| Office Action Summary | Application No. 10/586,069 | Applicant(s) FUKUSHIMA, SUSUMU | |

DETAILED ACTION

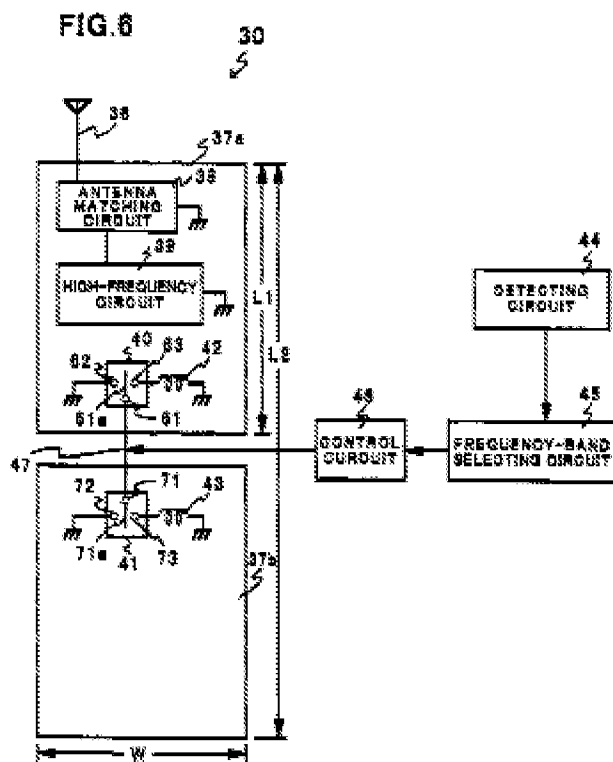
Ueda disclose in figure 6, a cellular phone comprising an antenna 36; a high-frequency circuit 39 connected via a matching circuit 38 to the antenna; a first printed substrate 37a which comprises a first ground section connected to the high-frequency circuit; a reactance circuit comprising inductors 42 and 43, wherein inductors 42 is connected to the first ground section; and a second printed substrate 37b which comprises a second ground section connected to the reactance circuit.

The cellular phone, further comprising a frequency band selecting circuit which examiner considers to be a transmitter-receiver; and a cable for connecting between the terminals (62-63 and 72-73) of the switches 40 and 41. The terminals (62, 63) are connected to the first ground section while the terminals (72, 73) are connected to the second ground section. Therefore, the cable provides connected between the first ground section and the second ground section and the frequency band selecting circuit.

The reactance circuit includes inductors 42 and 43 and a switches 40 and 41 for switching the inductors.

Ueda states that on receipt of the detection signal from the detecting circuit 44, the frequency-band selecting circuit 45 selects a desired frequency band, and transmits a selection signal indicative of the thus selected frequency band, to the control circuit 46.

On receipt of the selection signal from the frequency-band selecting circuit 45, the control circuit 46 transmits a control signal to both of the first and second high-frequency switches 40 and 41 through the cable 47. In accordance with the control signal, the contact plates 61a and 71a make pivotal movement around the base

contacts 61 and 71 to thereby make electrical contact with the first contact 62, 72 or the second contact 63, 73. The pivotal movement of the contact plates 61a and 71a around the base contacts 61 and 71 between the first and second contacts 62, 72 and 63, 73 causes a ground length in the cellular phone 30 to vary in accordance with a frequency band.
